DUKE POWER COMPANY
POWER BUILDING
422 SOUTH CHURCH STREET, CHARLOTTE, N. C. 28242

Mr. Edson G. Case, Acting Director
Office of Nuclear Reactor Regulation
U. S. Nuclear Regulatory Commission
Washington, D. C. 20555

Reference: Oconee Nuclear Station
Docket No. 50-269

Additional Information Required For The Oconee 1, 2, and 3
Fire Protection Revision

FIGURE 012578

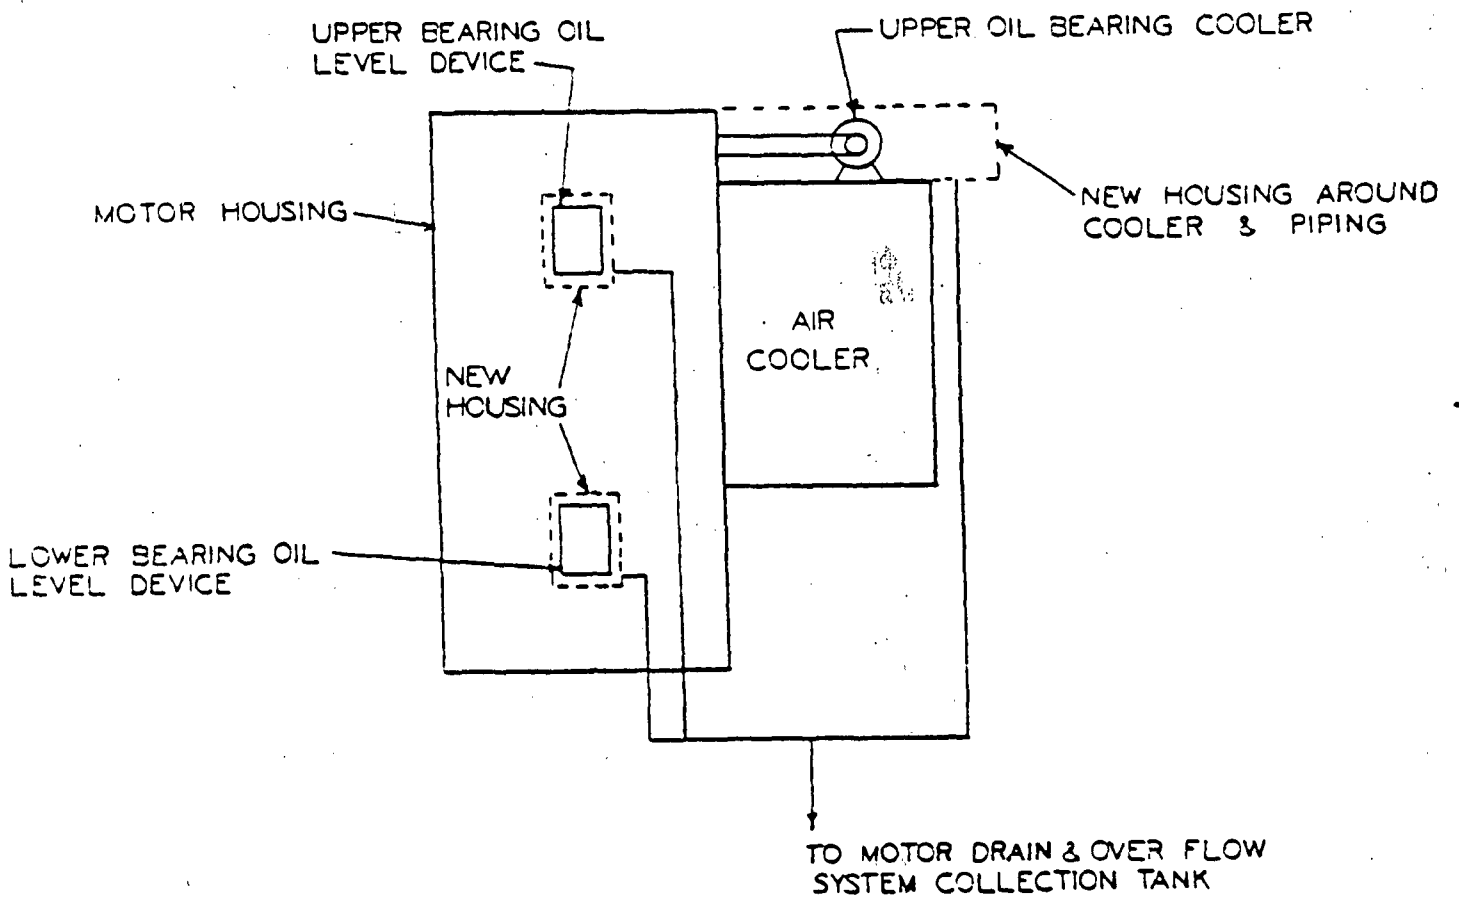
11. As illustrated in attached Figure 021578, the Reactor Coolant Pump Motor Drain and Overflow System will be modified to include housings and leak collection provisions around the upper and lower bearing oil level devices and the upper bearing oil cooler.

With this modification, all potential oil leaks of motor bearing oil will be collected and drained to the collector tank in the Reactor Coolant Pump Motor Drain and Overflow System.
